**YEAR 4 MONITORING REPORT**

**ROSES CREEK STREAM MITIGATION SITE**  
Burke County, North Carolina  
NC DMS Project # 96309

RE: NCDEQ – Division of Mitigation Services  
Roses Creek MY 4 Monitoring Report  
DMS Project Number: 96309  
Response to DMS Review Comments on Draft Year 4 Monitoring Report for Roses Creek

Figure 4.1 UT 1 Water Level

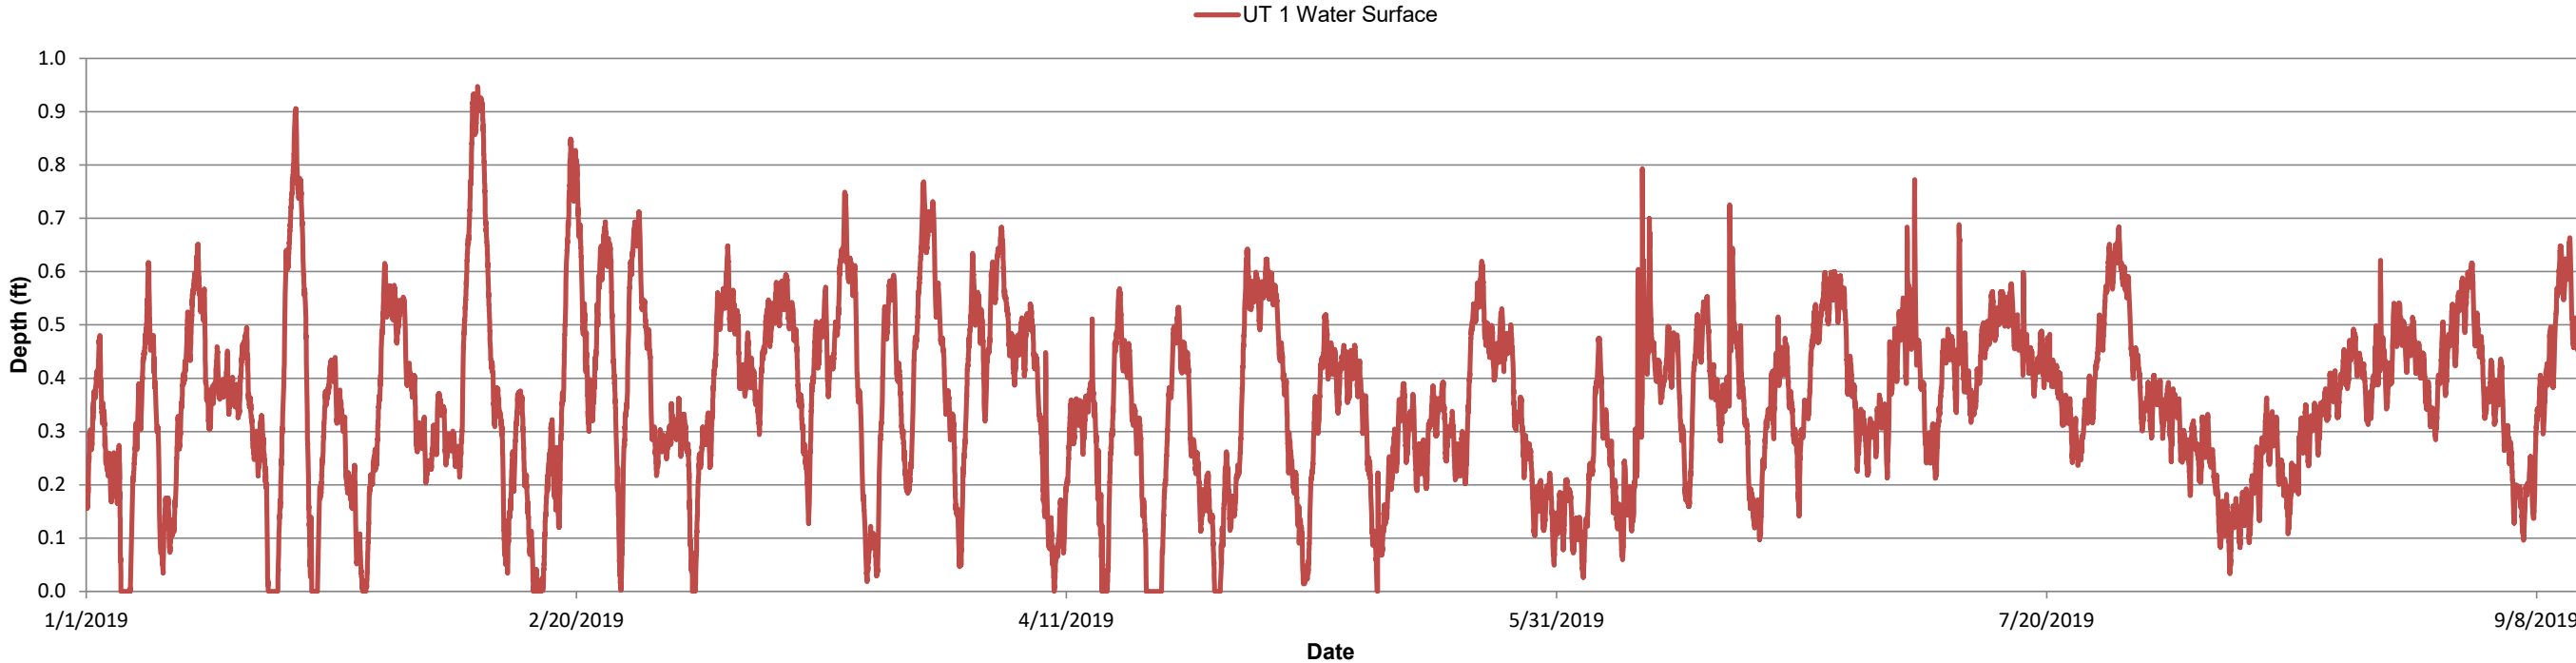
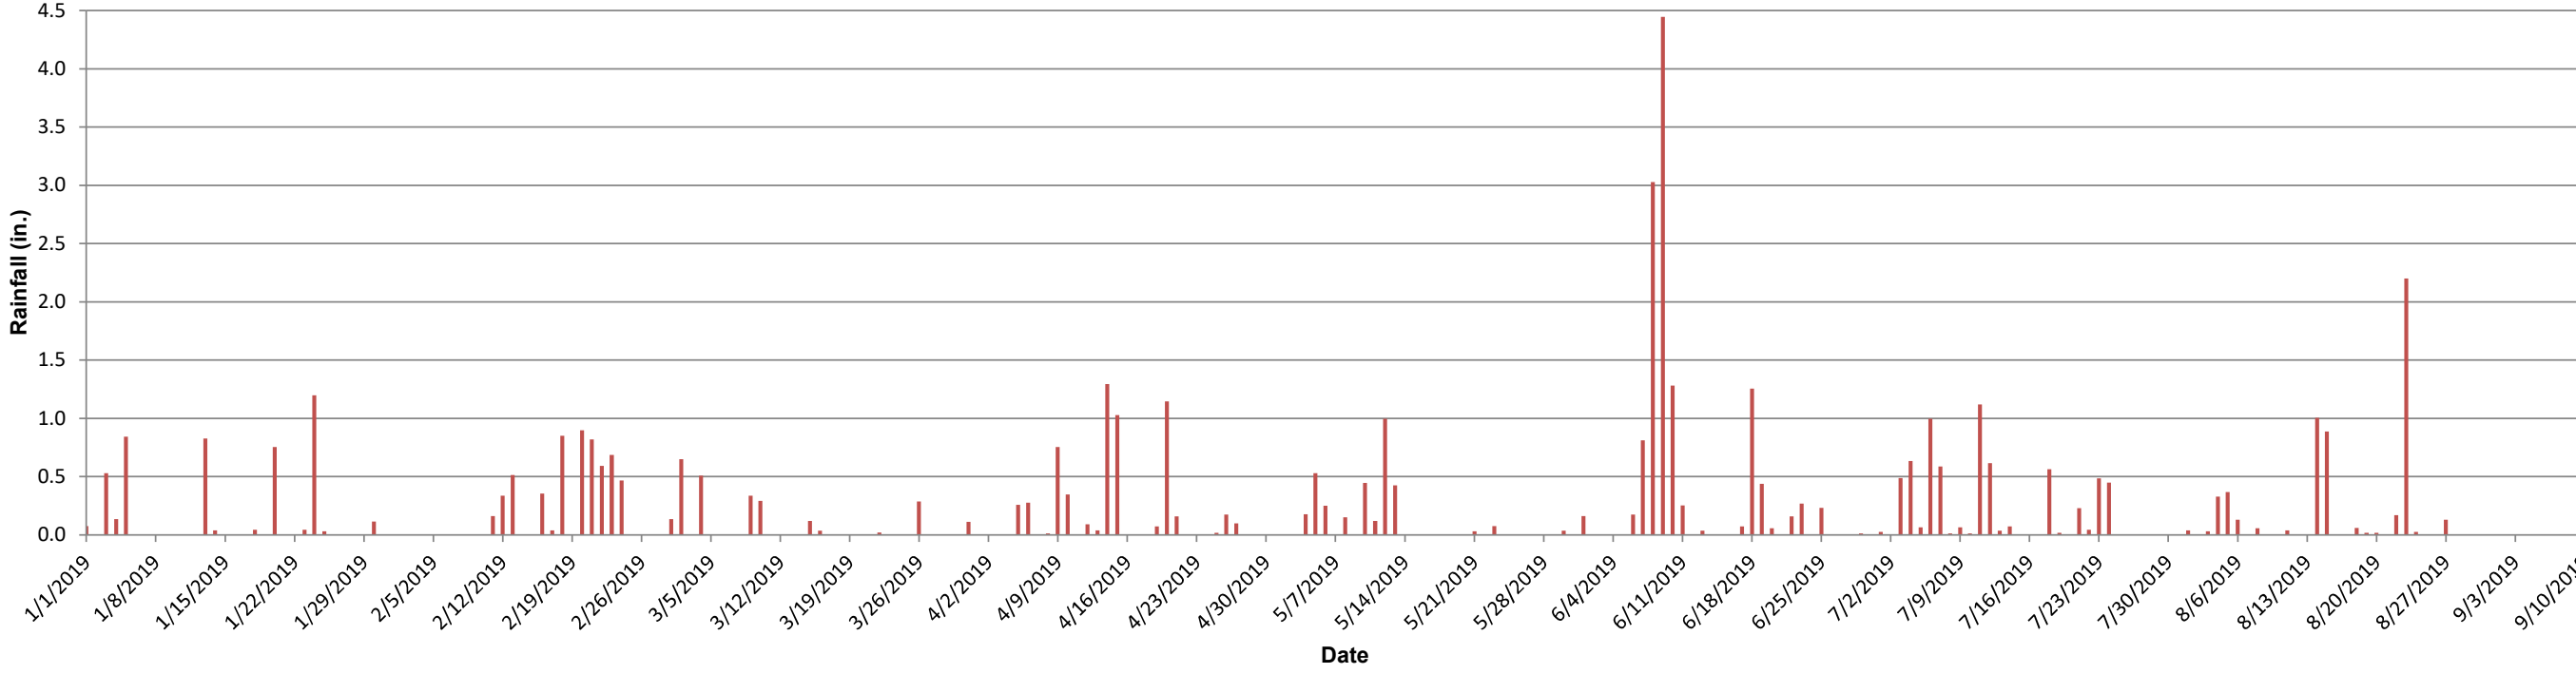
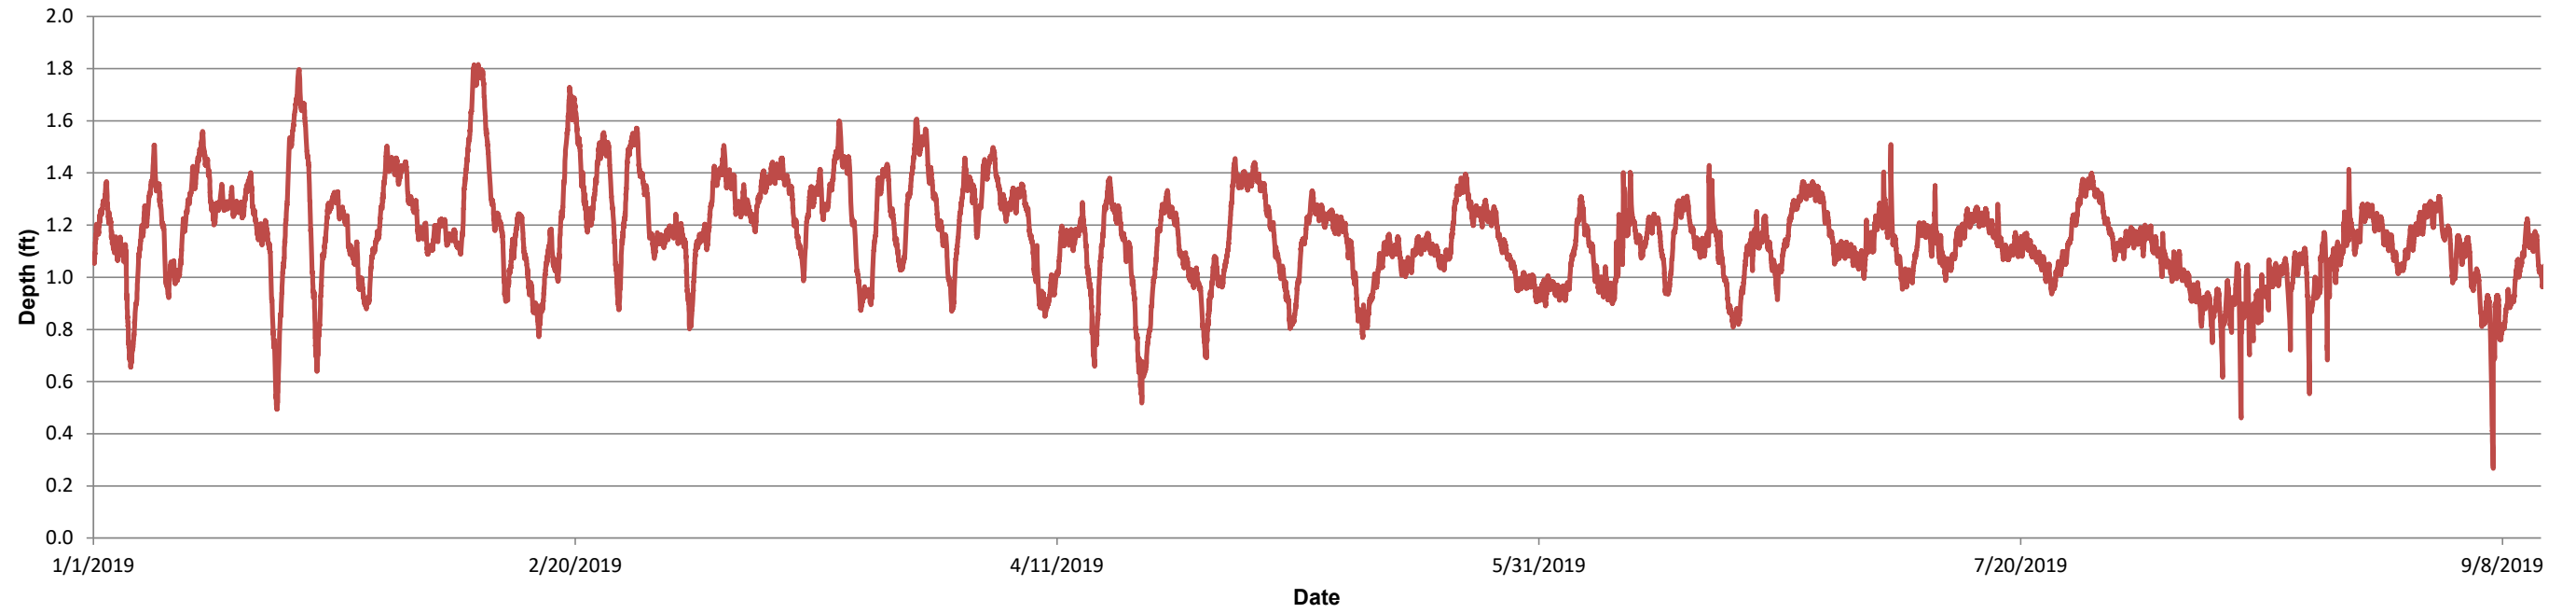
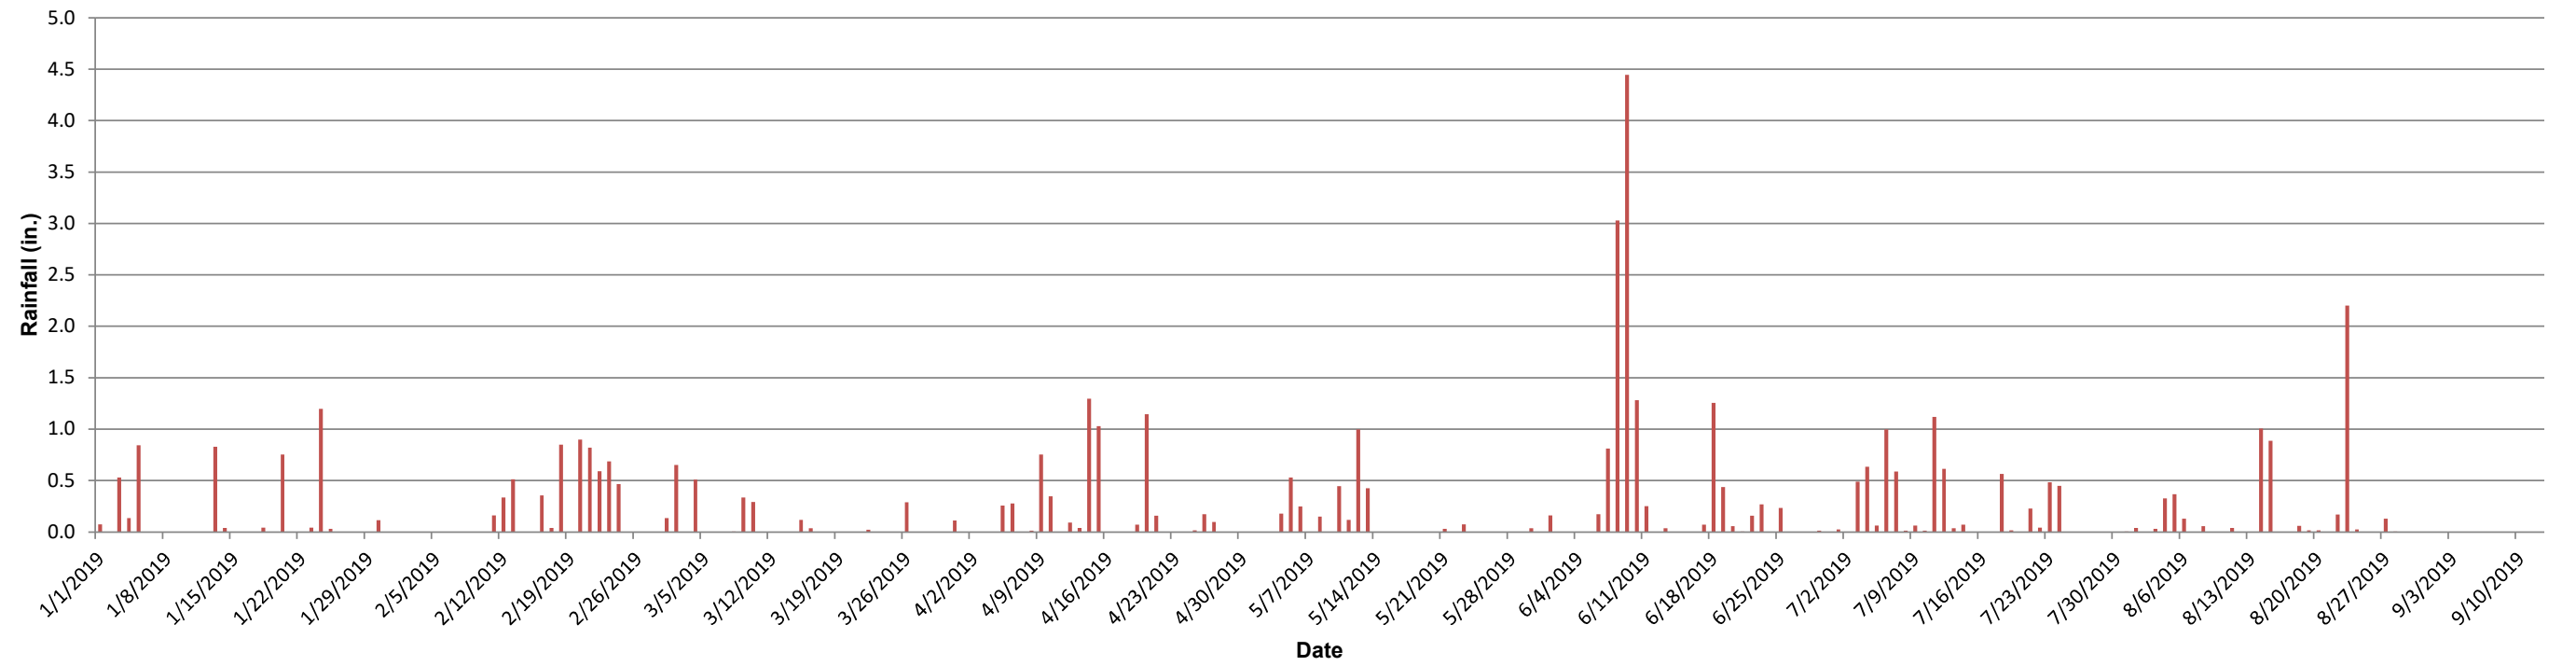
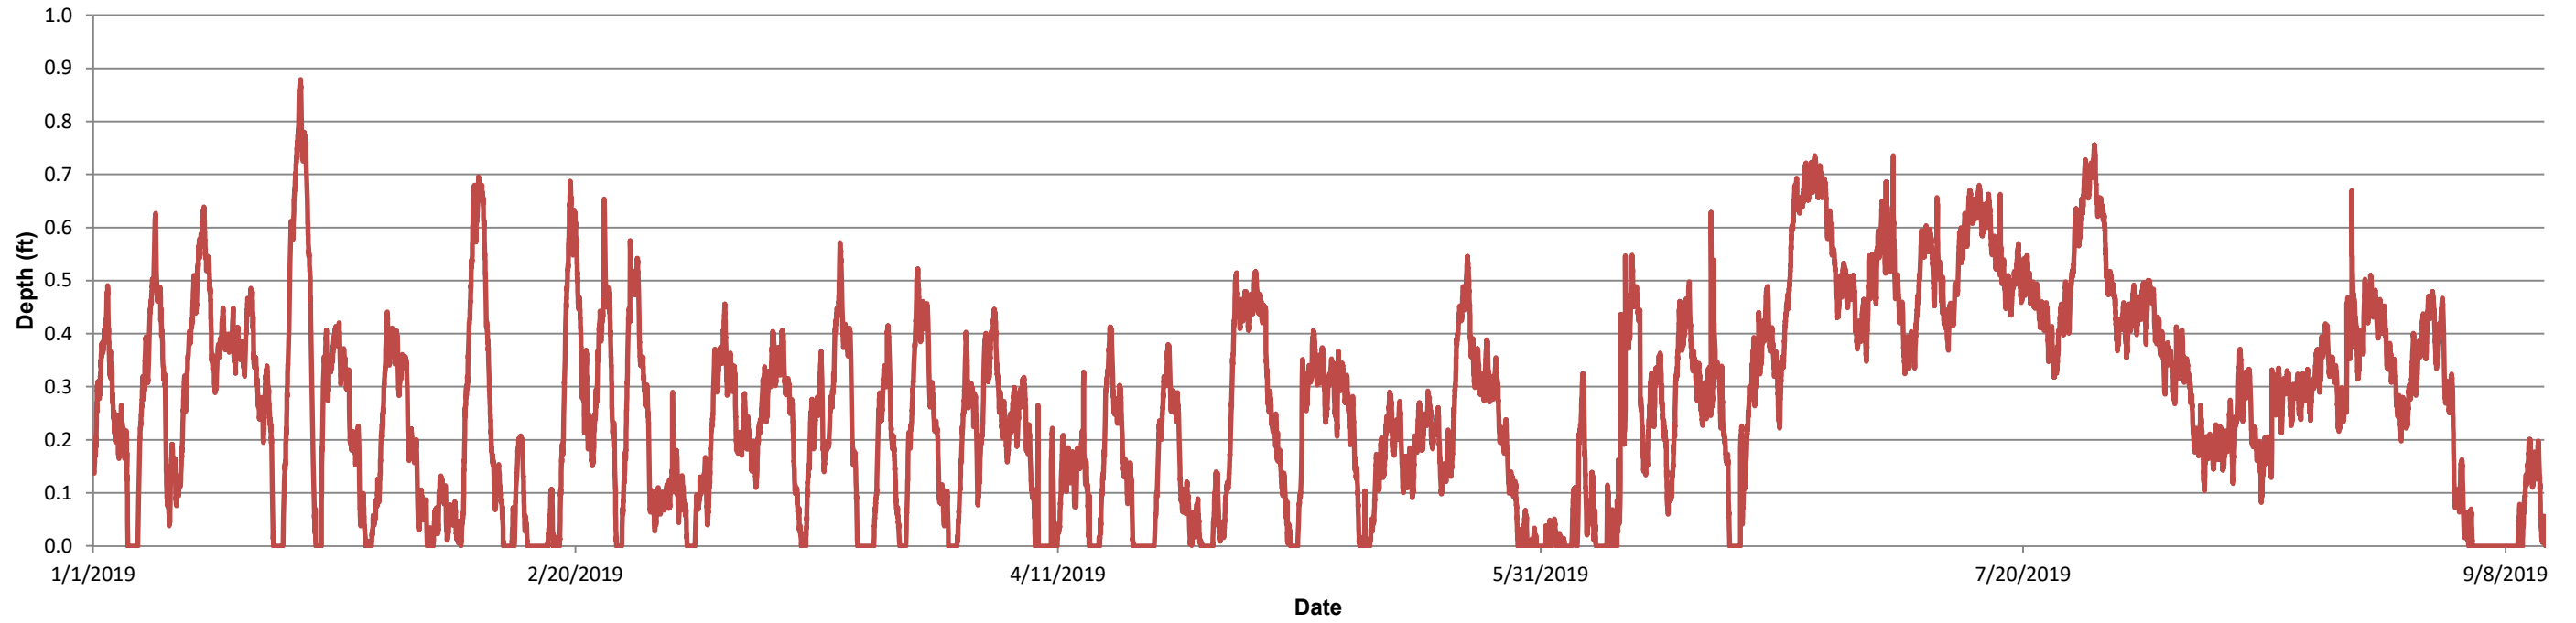
4. Fig 5.3 x-axis label has distance rather than time as a label.

6. Surface Water Level Meter Data – If available, rain data should be shown concurrently, with the most consecutive days/dates during which criteria were met.

*Response: The x-axis label has been corrected and Figure numbers for the Figure 5 series were changed to Figure 4 series to match figure numbering in the MY4 report.*

*Response: Rain data has been added to Surface Water Level figures.*
